a submission and further submissions by
the Hawke's Bay Regional Council ('**Regional
Council**')

Proposed Napier District Plan (PDP).

STATEMENT OF SUBMISSION – NAPIER PDP HEARING STREAM 2, 2-3 December 2024

Figure 4.3: Areas where different RMA instruments apply in the coastal space.

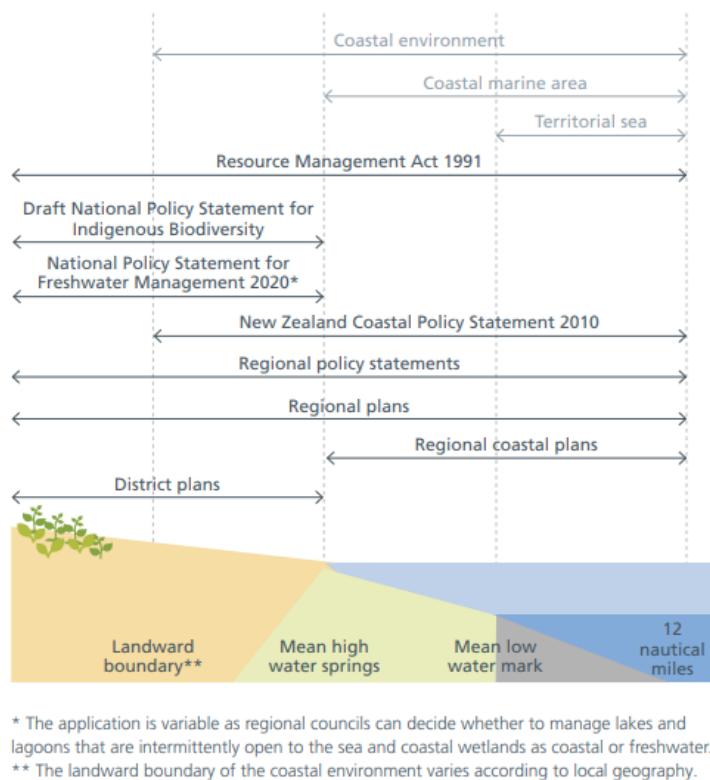
- 3.1 In reviewing the CE-Coastal Environment chapter, HBRC notes that an error has been made in the Introduction, where the division of responsibilities is described between HBRC and the City Council.
- 3.2 HBRC has responsibilities in the coastal environment both above and below mean high-water springs. Those on the landward side overlap with territorial authorities' responsibilities under s31(1), including with respect to management of natural hazards. This is illustrated in the diagram below, from the Parliamentary Commissioner for the Environment:

- 3.3 Policy 4 Integration of the NZ Coastal Policy Statement 2010 (NZCPS) provides for integrated management in the coastal environment, and requires, amongst other matters, particular consideration of situations where ‘development or land management practices may be affected by physical changes to the coastal environment or potential for inundation from coastal hazards...’ (Policy 4(c)(iii) NZCPS).
- 3.4 In light of the above paragraphs 3.4 to 4.3, HBRC considers it would be appropriate to correct this statement at paragraph 3 of the PDP, as suggested below *in italics*:

The management of this coastline is a collaboration between Napier City Council and Hawke’s Bay Regional Council. Napier City Council ~~manages~~ shares management of activities within the coastal environment landward of mean high-water spring with the Regional Council, while the Hawke’s Bay Regional Council is responsible for activities seaward of the mean high-water spring.

Figure 1: Overview of HBRC involvement in landward side of coastal environment

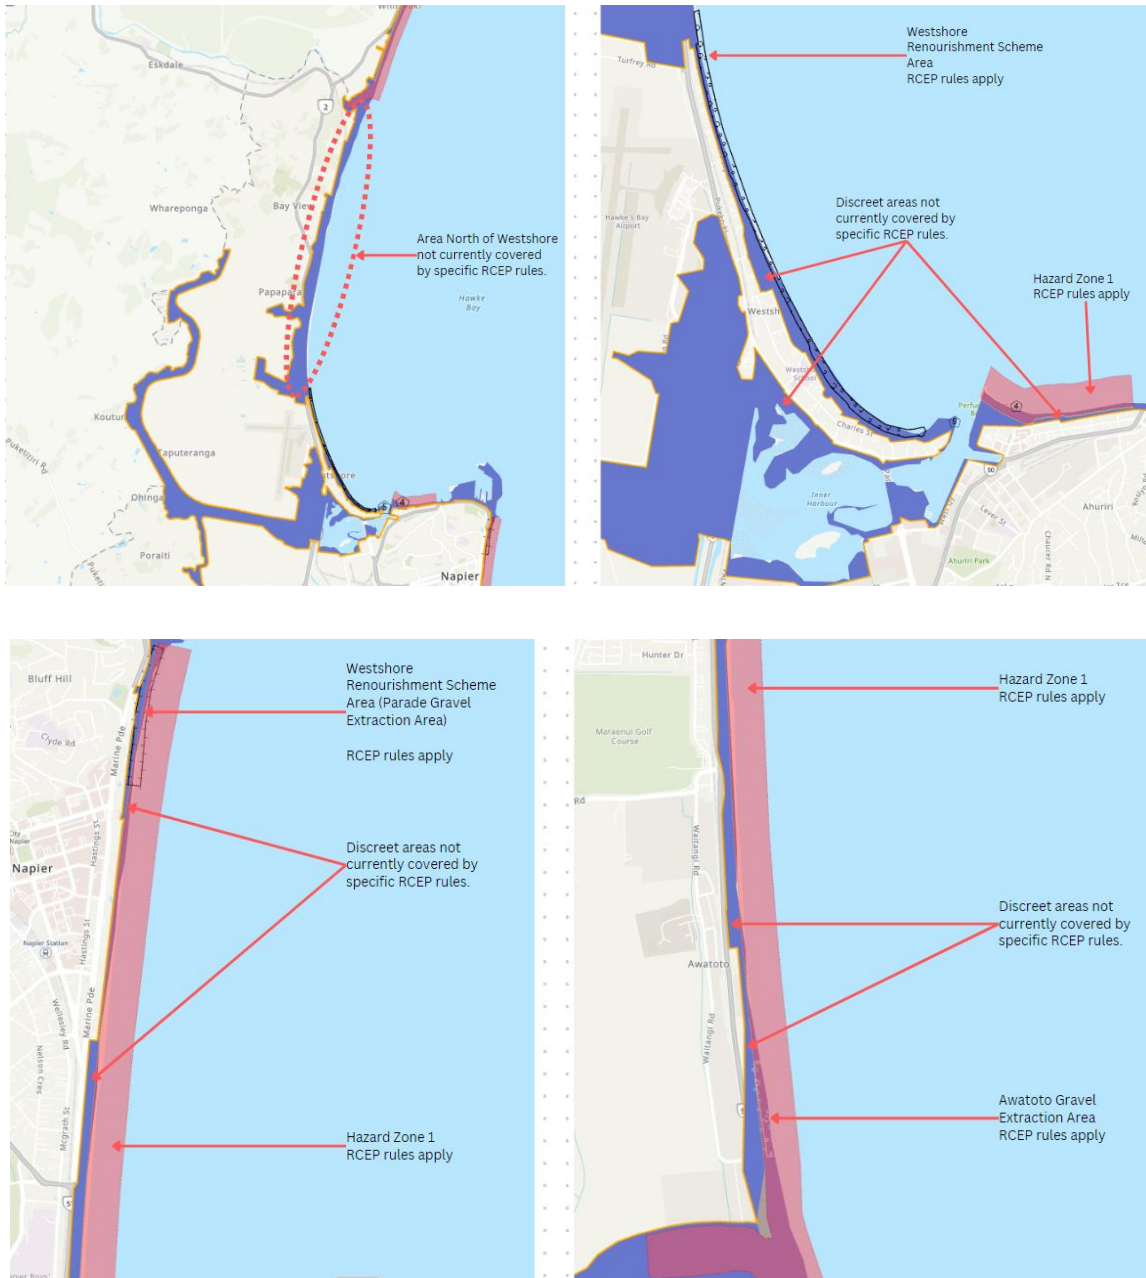
4.6 The maps on the following page illustrate the main areas where HBRC has an interest in these matters.

- 4.12 As illustrated in Figure 1, RCEP rules cover Hazard Zones, and mapped extraction and renourishment areas at Awatoto, Westshore and Marine Parade. Areas that are not currently addressed by specific RCEP rules are north of The Esplanade at Westshore (where extraction is not appropriate given that coastline is already vulnerable to ongoing erosion) and discreet areas within the coastal environment inland of mapped coastal hazard zones.

- 4.15 In the interim, HBRC requests that Rule EW-R6A is amended to remove duplication and improve consistency with RCEP provisions for small permitted takes, with changes shown in *italics* as follows:

Example 1: Poraiti

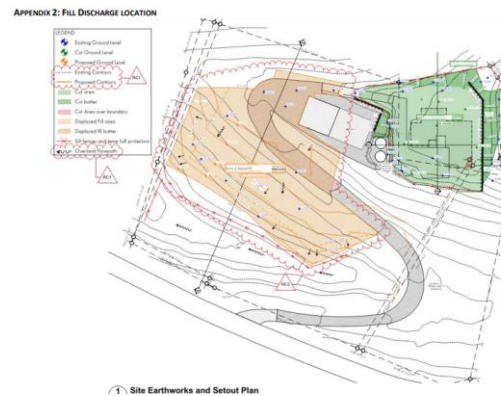
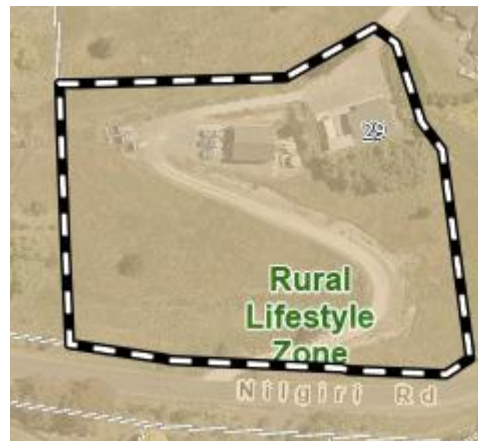
5.10.1 Poraiti: 9,930m² site, a very steep site also featuring a watercourse running through the property. The proposed drainage field was the south-facing slope, meaning there is a higher risk of slumping because of constant moisture being added through the wastewater system discharge. A work around was eventually found with some significant earthworks to create terraces and tertiary treatment (given the proximity to watercourses). This was a very drawn-out process which resulted in the land owner spending a lot of money on earthworks.

Example 2: Taradale

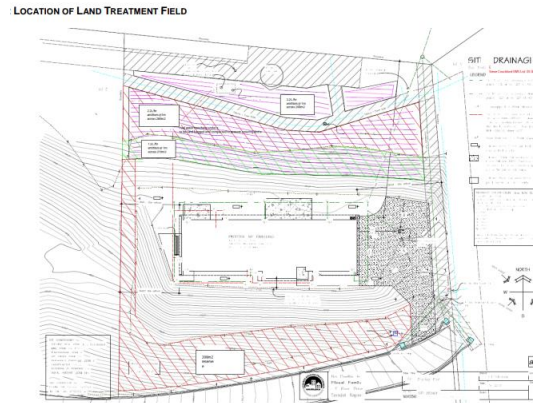
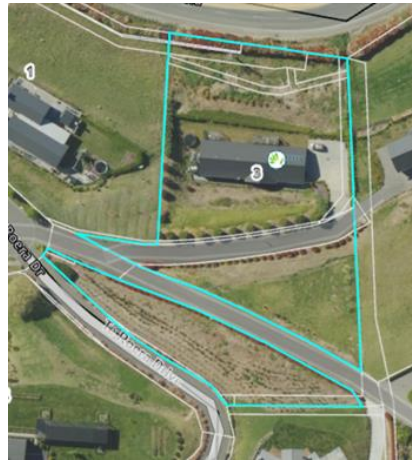
5.10.2 Taradale: 5,320m² allotment on relatively steep land, configured from a 3,710m² main allotment, tied across an access road to a 1,520m² allotment on higher ground. The house/ building platform is located on the lower third of the site, leaving a tight area for the on-site wastewater system drainage field, which itself has had to be split into three field drainage systems to accommodate easements on the land title. This is shown below:
